Re: Zoning Challenge for 5 West 13th Street, Block 577, Lot 34
DOB Job Number: M01164499

RE: Zoning Challenge
5 West 13th Street
Block 577, Lot 34
DOB Job Number: M01164499

At the request of a neighbor, our office has examined the accepted ZD1 for the proposed building at 5 West 13th Street (also known as 8 West 14th Street.) We are challenging both its zoning approval and ZD1 itself, based on DOB procedures and the Zoning Resolution.

Figure 1: Axonometric view of the proposed building created by my office using traditional land use colors.

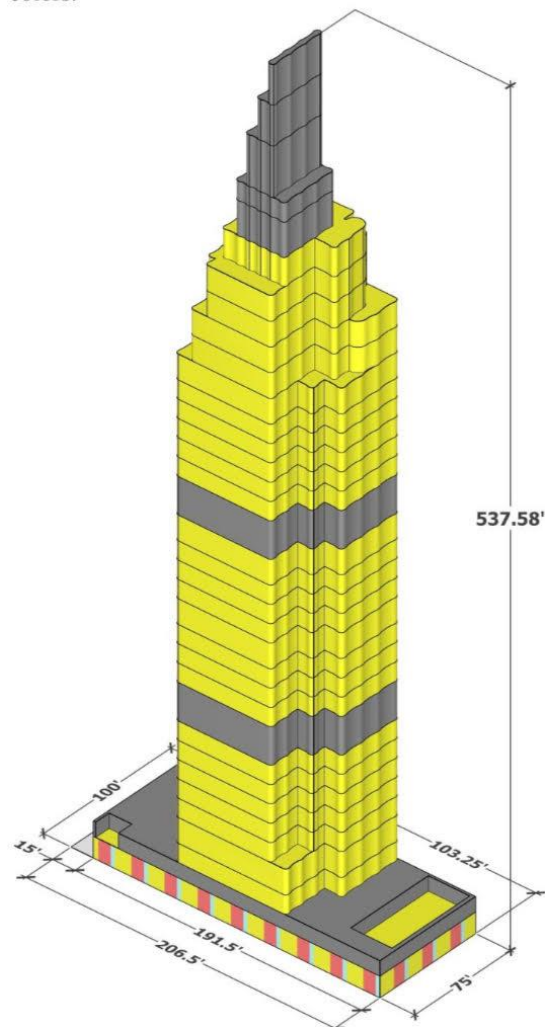
The ground floor is shown using multiple colors because the ZD1 does not show where the different uses are located.

Figure 2: Detail of an axonometric view found on the ZD1.

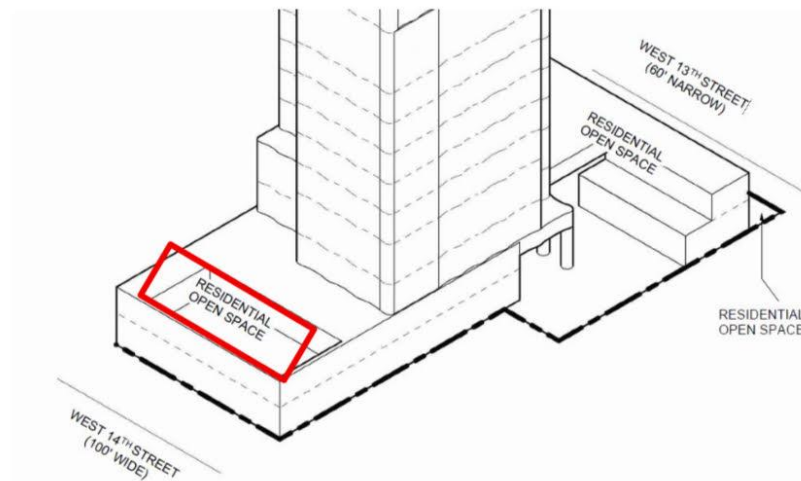
While the ZD1 lacks much of the detail necessary to critically evaluate their assumptions, the floor area table shows zero zoning floor area on the second floor. This is clearly wrong, as the ZD1 shows that there is zoning floor area on the

second floor. The following is a detail of “NW AXONOMETRIC DIAGRAM A” from the ZD1:

The area marked in red above with the label RESIDENTIAL OPEN SPACE appears to be a space on the roof of the first floor. It is enclosed on all sides by walls that form the second floor and has no roof. As you know, floor space enclosed by walls is zoning floor area under ZR 12-10. The fact that it has no roof does not matter for the purposes of defining zoning floor area. The proposed building completely builds out its residential floor area, and so any additional floor area added from this area will push this building out of compliance. Of course, as stated in Item 1, the building as designed is clearly not permitted, but if it were, it would be too large because this space would count as floor area.

Figure 3: The only site plan found on the ZD1. It shows exactly one dimension.

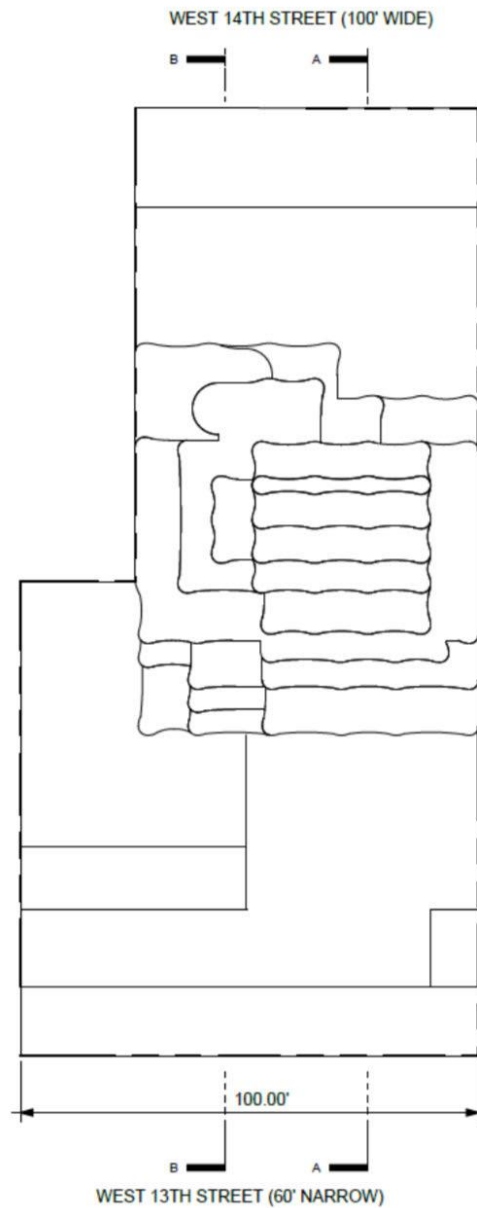
Most obviously, only one dimension is shown: the width of the lot on 13th Street. The ZD1 guide instructs that all lot dimensions and building dimensions should be shown. Further, the Zoning Diagram Guide instructs users to provide basic zoning measures that have simply been omitted. The following is captured from page 3 of the Zoning Diagram Guide:

In addition to a site plan with almost no information, there is nothing regarding lot coverage, lot area, street trees, or yards. The plan shows that onsite parking will be provided. Where is the detail on the curb cuts and splays, as required by the Zoning Diagram Guide? There is no zoning district identified. This missing information is especially material because the job is still in objections and full building plans are not available. The only information accessible to the public showing the applicant's intent is this woefully incomplete ZD1.
